dsPIC33EPXXXGM3XX/6XX/7XX Family Silicon Errata and Data Sheet Clarification

The dsPIC33EPXXXGM3XX/6XX/7XX family devices that you have received conform functionally to the current Device Data Sheet (DS70000689D), except for the anomalies described in this document.

The following typographic corrections and clarifications are to be noted for the latest version of the device data sheet (DS70000689D):

FIGURE 1: TIMING DIAGRAMS FOR CENTER-ALIGNED AND EDGE-ALIGNED MODES

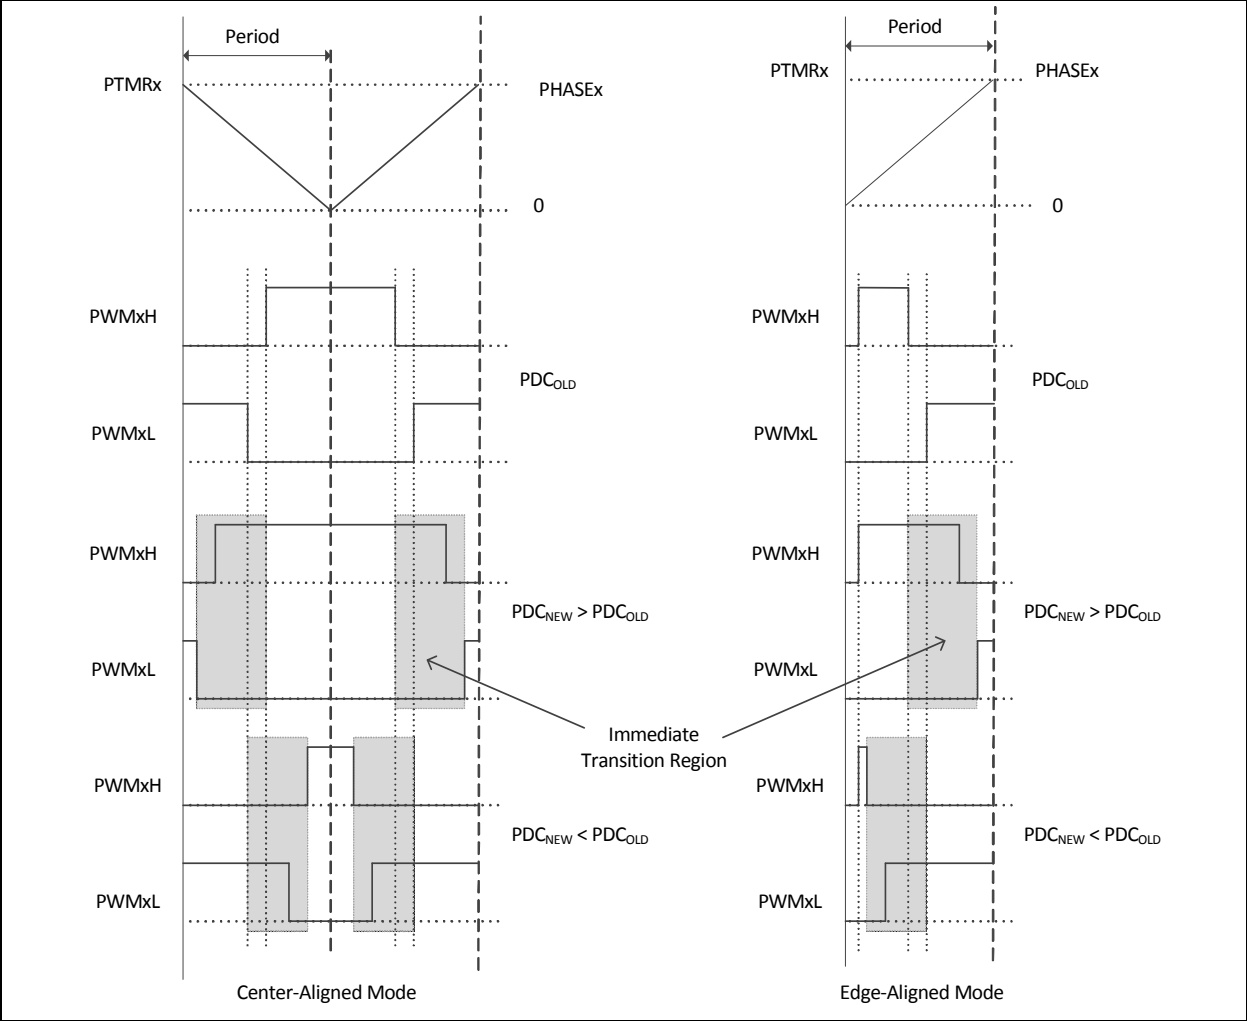
The PWM generator may not assert dead time on the edges of transitions. This has been observed when all of the following conditions are present:

- The PWM generator is configured to operate in Complementary mode with Independent Time Base (ITB) or master time base;
- Immediate update is enabled; and
- The value in the PDC register is updated in such a manner that the PWMxH and PWMxL outputs make an immediate transition.

The current duty cycle, PDC_{OLD}, newly calculated duty cycle, PDC_{NEW}, and the point at which a write to the Duty Cycle register occurs within the PWM

time base, will determine if the PWMxH and PWMxL outputs make an immediate transition. PWMxH and PWMxL outputs make an immediate transition if the Duty Cycle register is written with a new value, PDC_{NEW}, at a point of time when the PWM time base is counting a value that is in between PDC_{NEW} and PDC_{OLD}. Additionally, writing to the Duty Cycle register, close to the instant of time where dead time is being applied, may result in a reduced dead time which is effective on the PWMxH and PWMxL transition edges.

In [Figure 1](#), if the duty cycle write occurred in the shaded box, then PWMxH and PWMxL will make an immediate transition without dead time.

In most applications, the duty cycle update timing can be controlled using the TRIGx trigger, or Special Event Trigger, such that the above mentioned conditions are avoided altogether.

FIGURE 2: PWM GENERATOR TIMING DIAGRAM

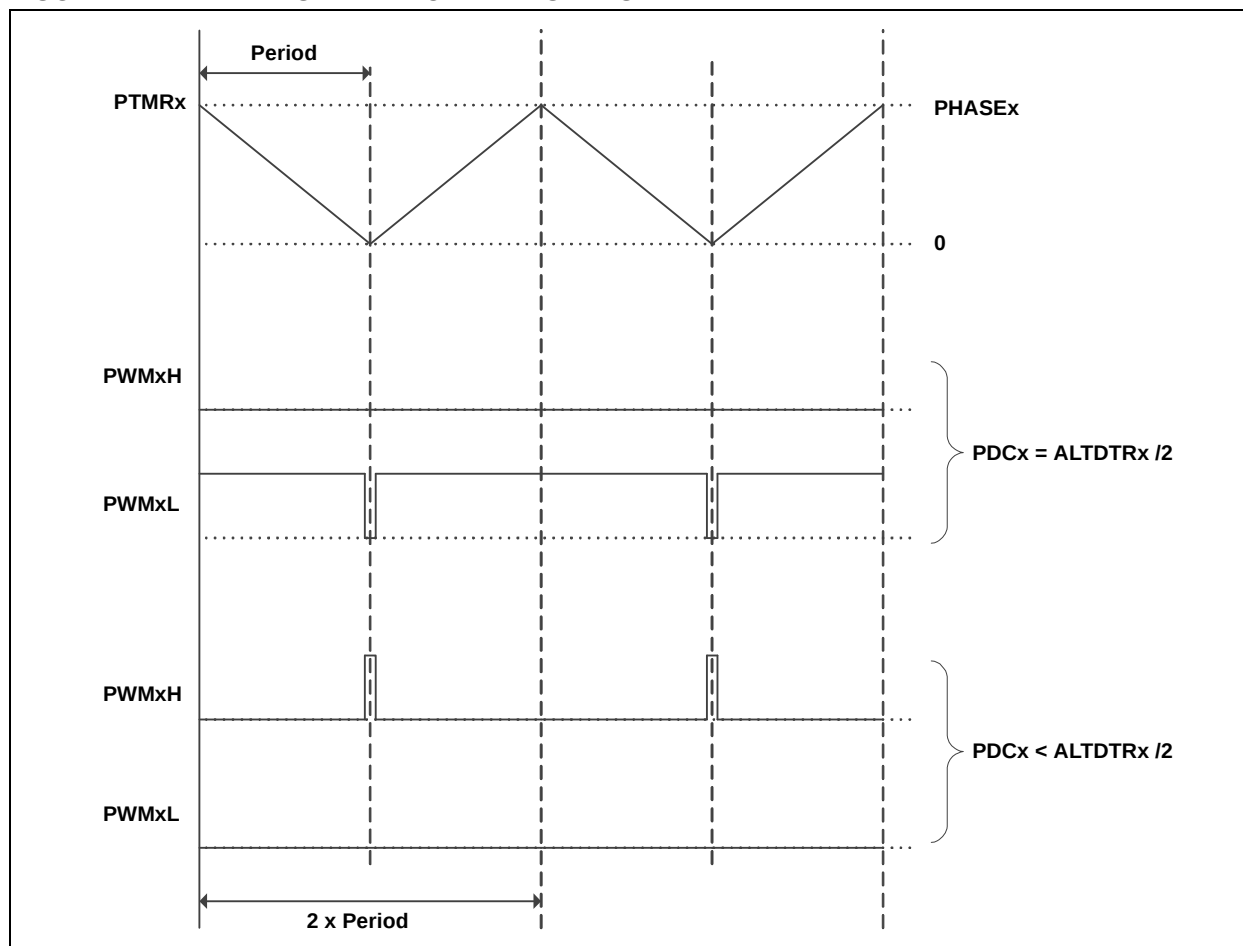
In Center-Aligned Complementary mode with Independent Time Base, if the value in the PDCx register is less than one-half the value in the ALTDTRx register, the PWM generator will force the PWMxL to low, and on the PWMxH, generates pulses of a width less than twice the dead time, as shown in Figure 2.

Include a software routine to ensure that the duty cycle value written to the PDCx register is at least one-half of the value in ALTDTRx. Example 1 shows one method, with PDCtemp representing the variable which has the value to be written to the PDCx register. Alternatively, for duty cycle values less than half the desired dead-time value, zero out the ALTDTRx register or dynamically reduce the value in the ALTDTRx register, such that ALTDTRx is always equal to $2 \times PDCx$, as shown in Example 2.

```
Altdtr_by2 = ALTDTRx / 2;
if (PDCtemp < Altdtr_by2)
{
    PDCx = Altdtr_by2;
}
else
{
    PDCx = PDCtemp;
}
```

```
#define DESIRED_DEADTIME 100
if (PDCtemp < (DESIRED_DEADTIME/2))
{
    ALTDTRx = PDCtemp * 2;
    PDCx = PDCtemp;
}
else
{
    ALTDTRx = DESIRED_DEADTIME;
    PDCx = PDCtemp;
}
```

FIGURE 3:

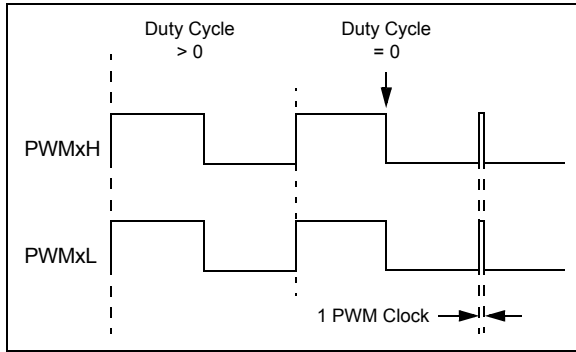
In certain output modes, the PWMx module produces a pulse glitch of one PWM clock in width (Figure 3). This has been observed only when all of the following are true:

- Either Redundant or Push-Pull Output mode is selected ($\text{IOCONx}<11:10> = 10$ or 01);
- Immediate Update is disabled ($\text{PWMCONx}<0> = 0$); and
- The value of the current Duty Cycle register (either the PDCx or MDC register, as determined by $\text{PWMCONx}<8>$) is updated to zero from any non-zero value.

The pulse glitch has been observed to occur at the beginning of the following PWM boundary period.

If the application requires a duty cycle of zero, two possible work arounds are available.

1. Use the PWM overrides to force the output to a low state, instead of writing a '0' to the Duty Cycle register. When using this method, the PWM override must be disabled when the duty cycle is a non-zero value. If output override synchronization is configured to occur on CPU clock boundaries ($\text{IOCONx}<0> = 0$), enabling and disabling the override must be timed to occur as closely as possible to the PWM period boundary.
2. Configure the module for Immediate Update ($\text{PWMCONx}<0> = 1$) *before* enabling the module. In this mode, writes to the Duty Cycle register have an immediate effect on the output. As with the previous work around, writes to the Duty Cycle register must be timed to occur as close to the PWM period boundary as possible in order to avoid distortion of the output.

FIGURE 4:

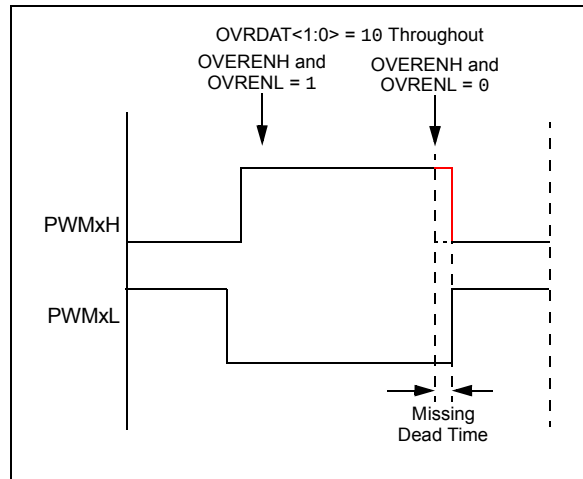
In Complementary Output mode, the expected dead time between transitions of the PWMxH and PWMxL outputs may not be asserted when the following occurs:

- Output override synchronization is configured to occur on the CPU clock boundary ($\text{IOCONx}<0> = 0$);
- Both PWMxH and PWMxL overrides are enabled prior to the event (OVRENH and OVRENL are both '1'), and
- Both overrides are disabled (OVRENH and OVRENL are both '0') at the instant the dead time should be asserted (Figure 4).

This has been observed in both Center-Aligned and Edge-Aligned modes.

FIGURE 5:

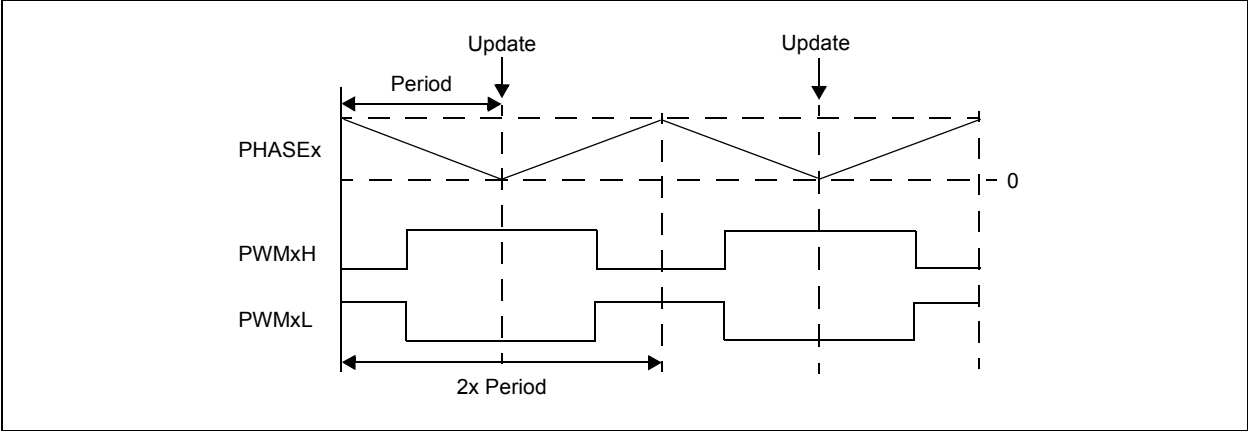
In Center-Aligned Complementary mode with Independent Time Base, updates to the PHASEx register take effect in the middle of a Center-Aligned PWM cycle, as shown in Figure 5. This occurs only when the Immediate Update feature is disabled (IUE = 0). If Immediate Update is enabled (IUE = 1), the PHASEx register updates will take effect immediately.

FIGURE 6:

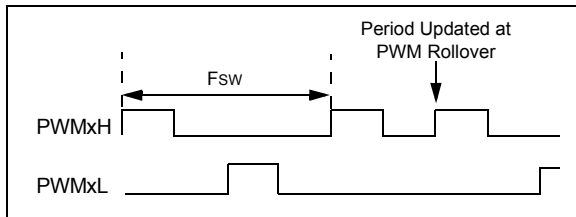
When the PWM module is configured for Push-Pull mode (IOCONx<11:10> = 10) with the Enable Immediate Period Update bit enabled (PTCON<10> = 1), a write to the Period register that coincides with the period rollover event may cause the push-pull output logic to produce back-to-back pulses on the PWMx pins (Figure 6).

Ensure that the update to the PWM Period register occurs away from the PWM rollover event by setting the EIPU bit (PTCON<10> = 1). Use either the PWM Special Event Trigger (SEVTCMP) or the PWM Primary Trigger (TRIGx) to generate a PWM Interrupt Service Routine (ISR) near the start of the PWM cycle. This ISR will ensure that period writes do not occur near the PWM period rollover event.

FIGURE 7: SIMPLIFIED BEHAVIOR

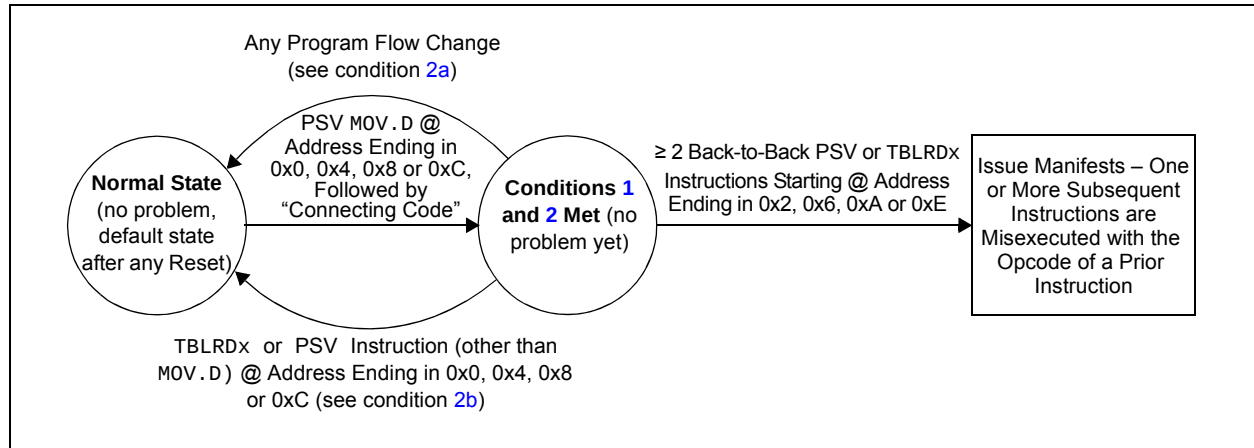
3.	≥ 2 back-to-back PSV or TBLRDx instructions are executed (following the code of condition 2), where the first of the back-to-back instructions is located at an address ending in 0x2, 0x6, 0xA or 0xE.

[Figure 7](#) provides an example of the effective behavior.

1. All instances of PSV MOV.D can be replaced with two PSV MOV instructions instead. Non-PSV MOV.D instructions acting on RAM/SFRs do not need to be modified; or
2. If not already present, a program flow change instruction (such as BRA \$+2) can be inserted above back-to-back data Flash read sequences; or
3. Back-to-back data Flash read instruction sequences can be broken up by inserting a non-Flash read instruction (such as a NOP), in between the Flash read instructions; or
4. The alignment of the code can be shifted to avoid the required opcode location addresses.

C code built with MPLAB® XC16 Compiler Version 1.32, or later, implements the work around by default. However, if the application uses Assembly language routines, these should be manually modified to implement the work around. Additionally, if precompiled libraries are used, these should be built with XC16 Version 1.32 or later. For additional information, please visit: www.microchip.com/erratum_psrds_psrds

64-Lead Plastic Quad Flat, No Lead Package (MR) – 9x9x0.9 mm Body with 5.40 x 5.40 Exposed Pad [QFN]

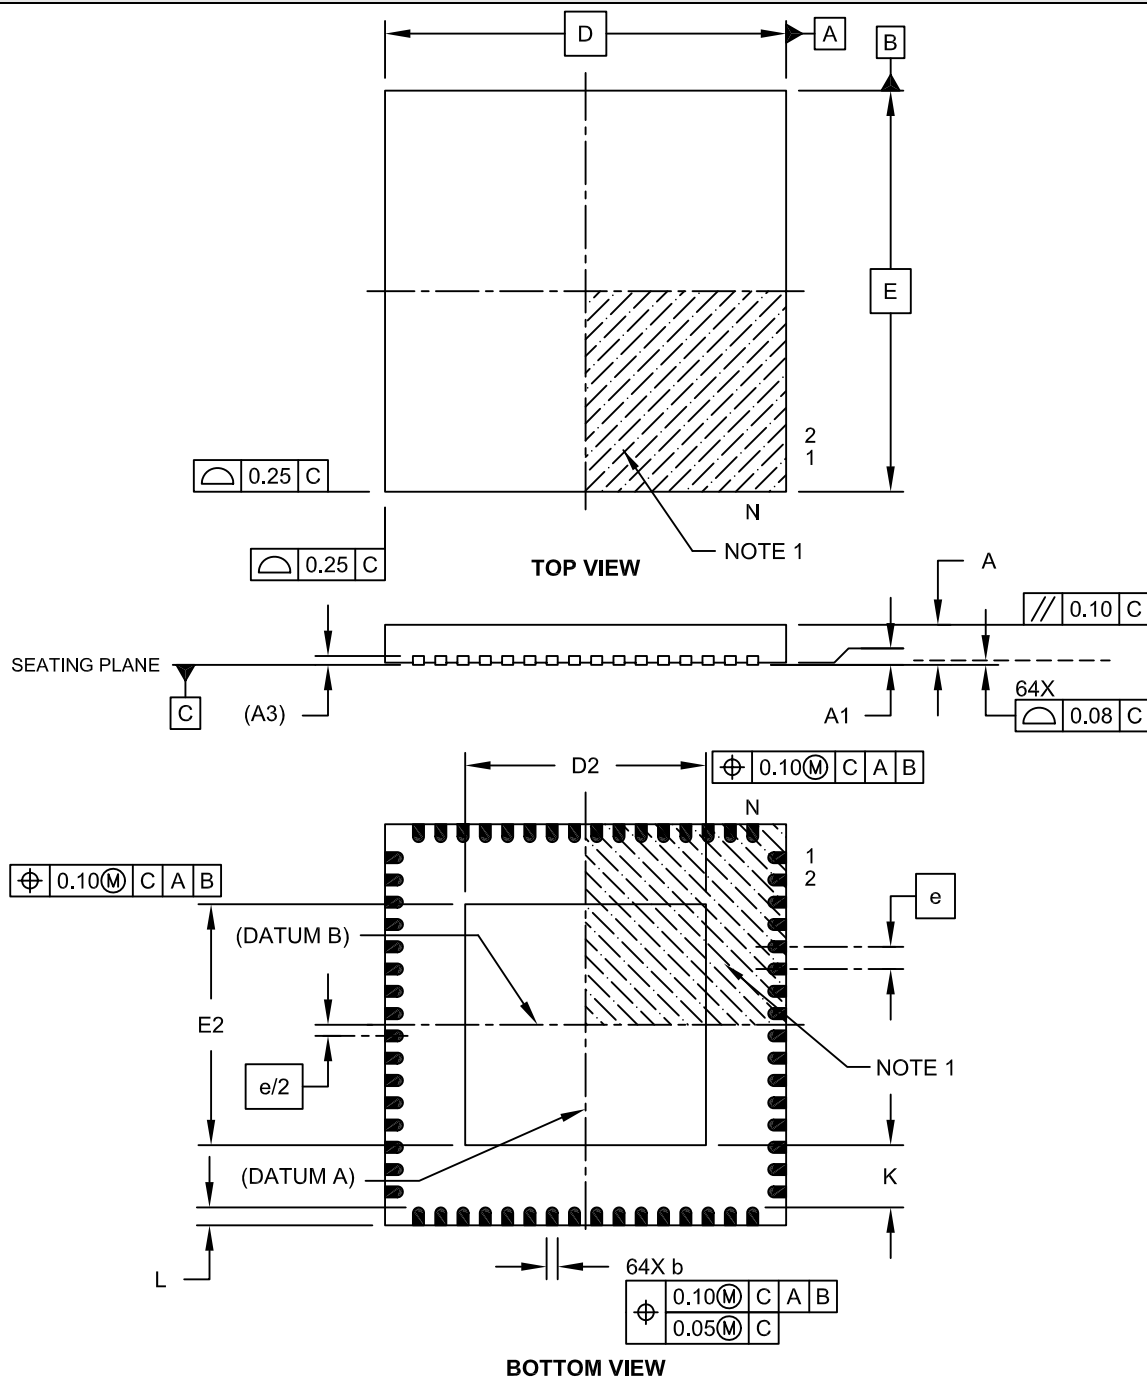
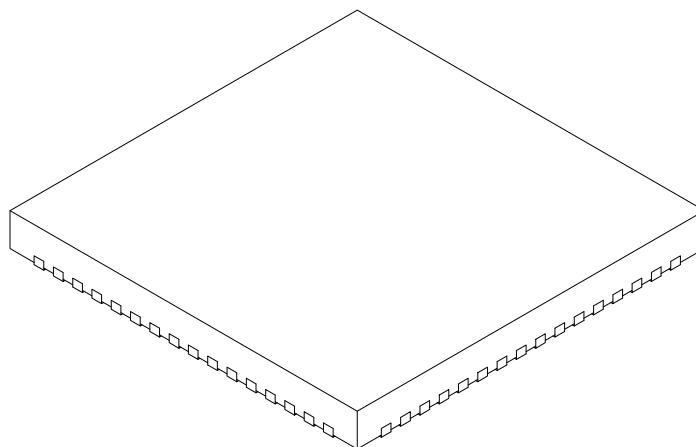
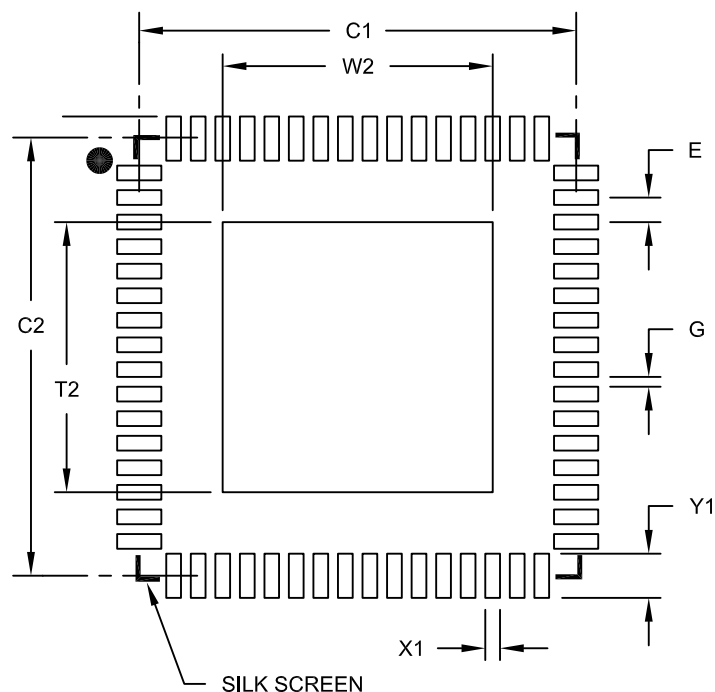
In the “dsPIC33EPXXXGM3XX/6XX/7XX Family Data Sheet”, **Section 35.2 “Package Details”**, dimensions for the 64-Lead Plastic Quad Flat, No Lead Package (MR) – 9x9x0.9 mm Body with 7.15 x 7.15 Exposed Pad [QFN] is mentioned. However, the dsPIC33EPXXXGM3XX/6XX/7XX family devices are not available in this package.

The dsPIC33EPXXXGM3XX/6XX/7XX family devices are available in the 64-Lead Plastic Quad Flat, No Lead Package (MR) – 9x9x0.9 mm Body with 5.40 x 5.40 Exposed Pad [QFN], and the package dimensions are shown on the following pages.
